Comment Letter I104

Response to Comment Letter I104

Re: Boulevard Community Opposing the Proposed Soitec Solar Projects

I104-9	This comment includes photos of the visual character of the Proposed Project area. Refer to the response to comment I104-6.
Attachment Comment I104-9

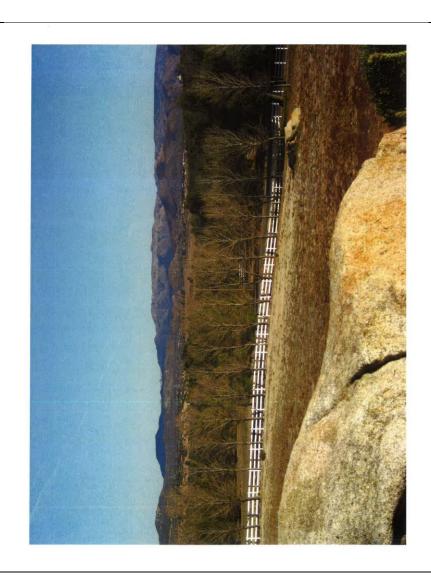
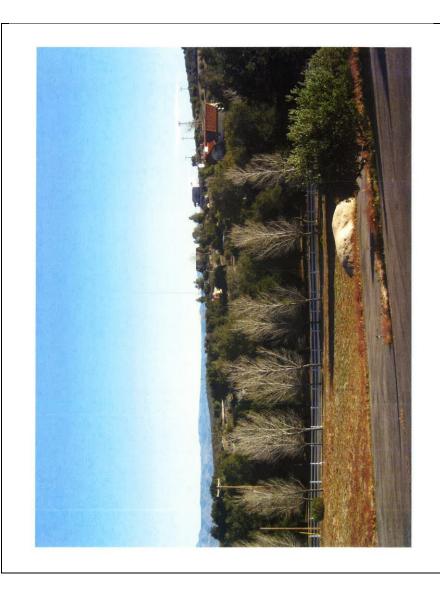
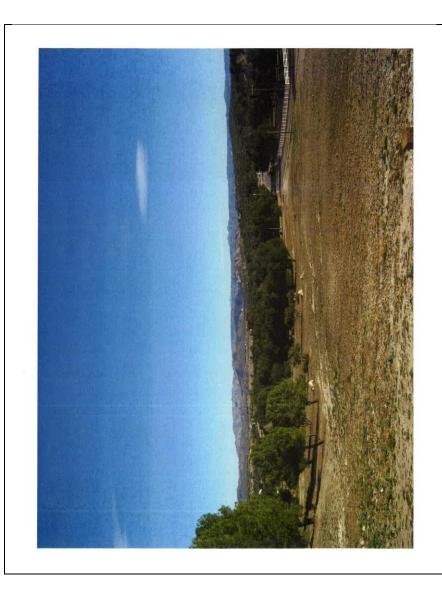
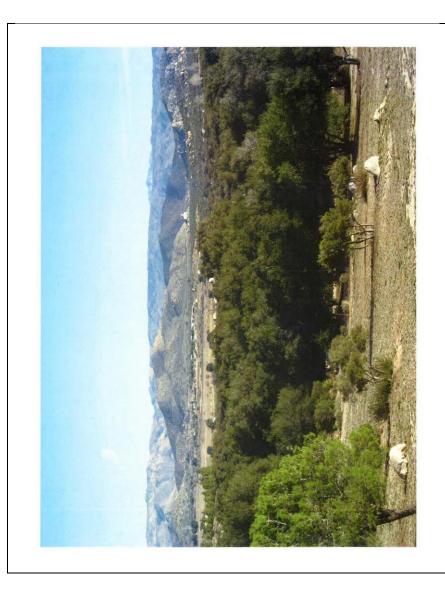
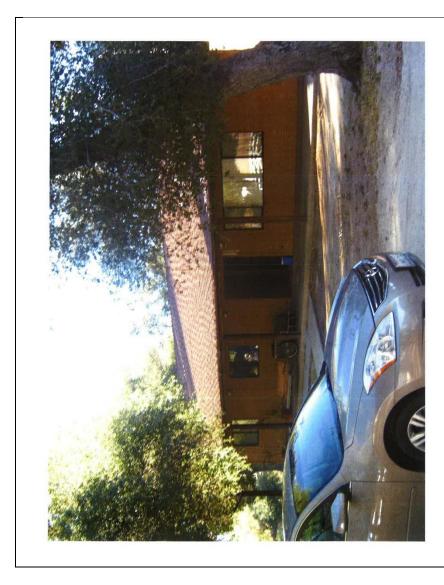
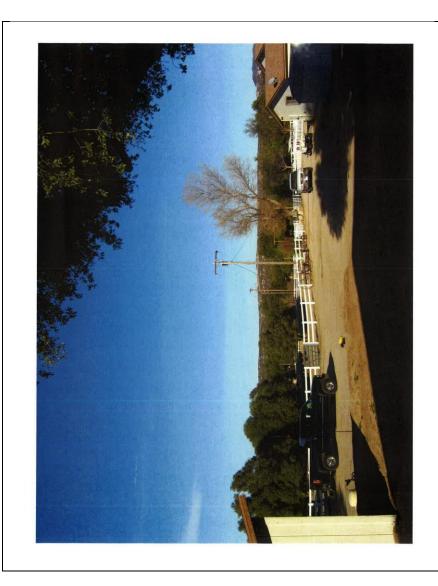
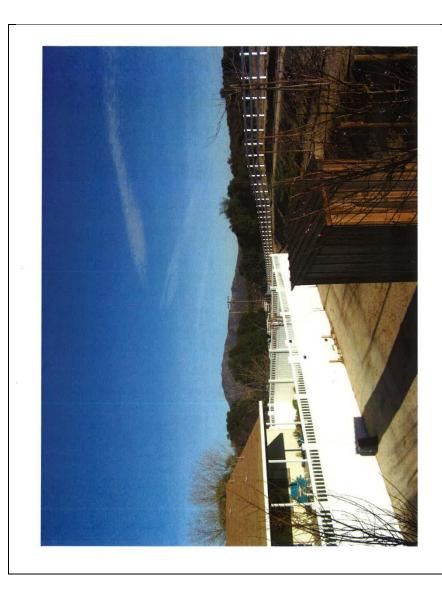
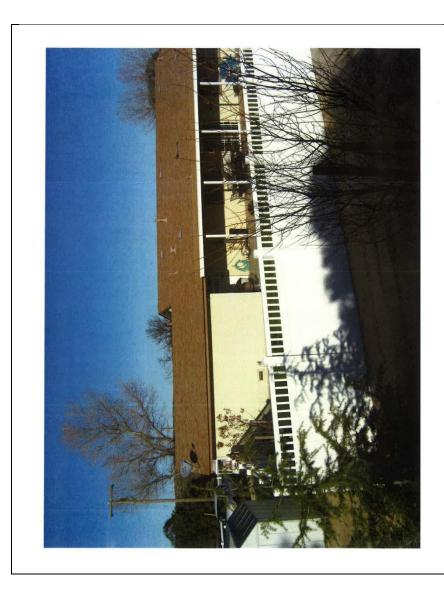
access these residences. Therefore, local residents' exposure to the project site is anticipated to be similar as motorists on Interstate 8 or McCain Valley Road." This statement is untrue. Please find the attached photos for review showing the TRUE reflection of our community and homes. These photos were taken from the back yards of residences' of several homes located in the Rancho Boulevard Estates looking east directly to the proposed Rough Acres site. Most assuredly, the residents of the Boulevard Estates will lose their visual beauty if solar project is approved.

The County appreciates the photos submitted by the commenter. These will be included in the FPEIR for review and consideration by the decision makers. It should be noted that per CEQA Guidelines (14 CCR

15000 et seq.) and County guidelines for determining significance, visual analysis of Proposed Project effects is required only from public viewpoints. CEQA analysis is not required for views from private property. However, considerations of community character and local visual resources were analyzed in the DPEIR, as previously described in this response.
